INDESIT company

Model type:
TAN2S

Commercial code:
F034169

51421M0

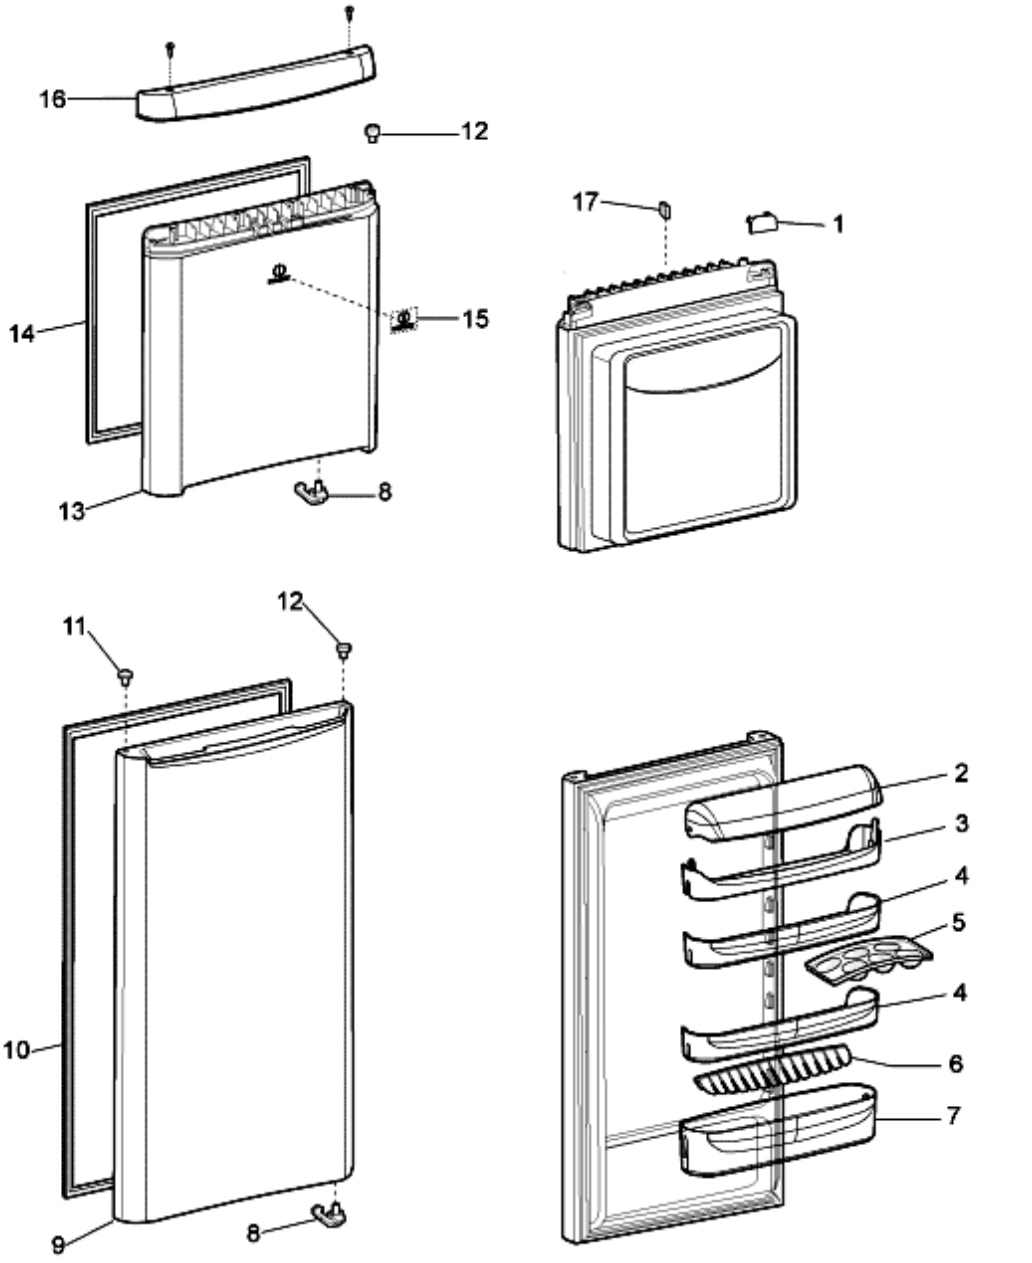
n2507b01: Color change on inner door upper heading

From s/n 70129.0001 (January 2007) on teak – inox – silver Indesit models has been introduction in production a new white inner door upper heading / white hinge blanking plate.

The spare part code of the door remain the same.

When replacing the door in the products produced before the modification replacing also the brown hinge blanking plate (for teak versions), grey (for silver version), aluminium (for inox versions) with the white.

n2511b02: ELIMINATION COVER FOR UPPER DOOR SHELF-INTERNAL ACCESSORIES RESTYLING

Cover for upper door shelf has been eliminated. The upper door shelf has been standardized with the middle one. Subsequently has been standardized with transparent internal accessories instead of those in light blue colour once stock has depleted.

5142260 Exploded views

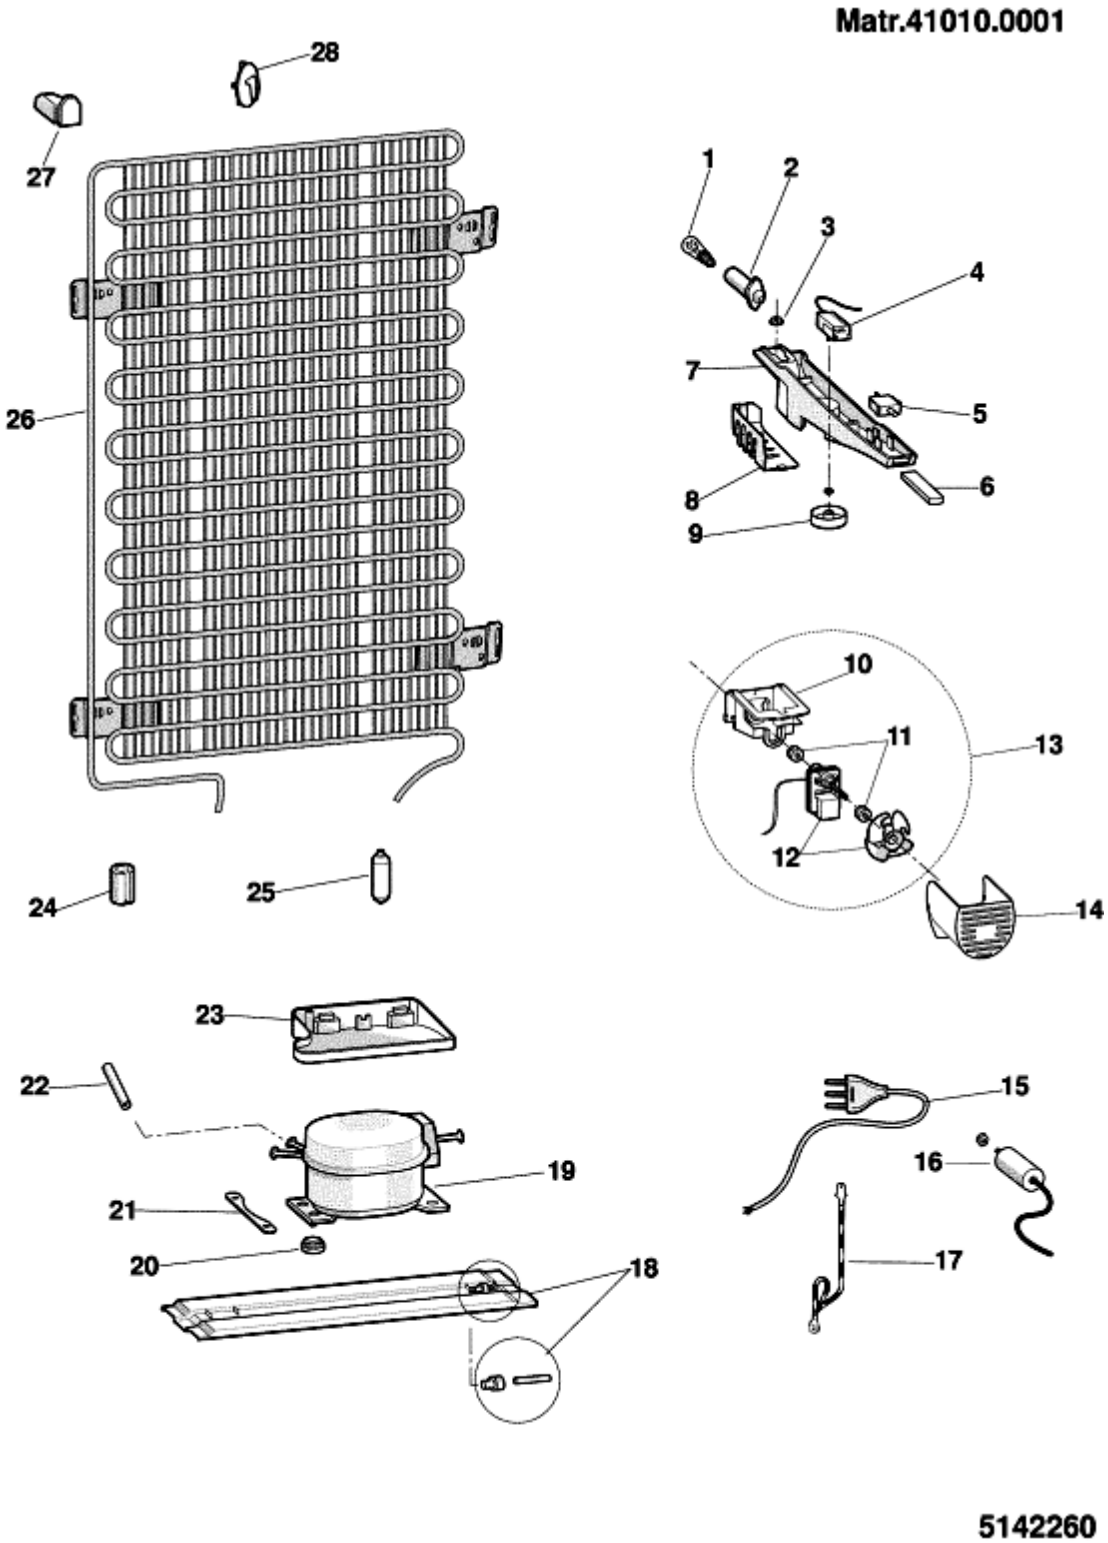
n1025101: Disappearing bulb thermostats (warning!)

The apparatus that provide for the thermostat to be threaded into a small tube located inside the fridge cabinet are noted as versions with "disappearing bulbs".
The bulb must be inserted for a length equal to the position indicated on the colored ribbon (small mark) which confirms the correct position of the bulb in the evaporation area, otherwise causing the poor performance of the apparatus.
Therefore in cases of thermostat replacement it will be necessary to reset on the new, if missing, the same small mark position and always check that the thermostat bulb is completely devoid of the sheath so as to ease its insertion.
The entrance of the small tube, placed in the thermostat container, is protected by a perforation cover in order to avoid the formation of condensation. The perforation cover was initially situated externally and could be substituted with putty or silicone.
For the models with disappearing bulb thermostats, the spare parts are inclusive of the small colored marker,

however check that its position corresponds to that on the thermostat that will be replaced.
The spare part description always notes the position of the small marker in millimeters as well as the thermostat initials.

n1025135: Thermostat box on Indesit/Ariston Opera-60 refrigerators (low A.T. +16°C)

As of July 2003, two new "Low ambient temperature thermostat box kits" have been introduced as spare parts for Ariston Opera-60 and Indesit 2000 - 2002 - 2003 range refrigerators with Giugiaro thermostat box (075646).

The kit must only be used to solve freezer performance problems caused by an ambient temperature below +16° C.
This innovative kit features a DIODE, activated by means of the luminous switch, which makes the thermostat box lamp turn on. It must be activated when the ambient temperature falls below +13°C (closed contacts: see the wiring diagram that comes with the kit).
The heat produced by the lamp activates the thermostat, thus ensuring regular operation of the appliance.
When replacing the thermostat box, no component can be reused (including the wiring).
The kit wiring has pin terminals for connection to the terminal block on the compressor; some modifications may be required for other solutions.
Given below is the list of kit items available as spare parts:
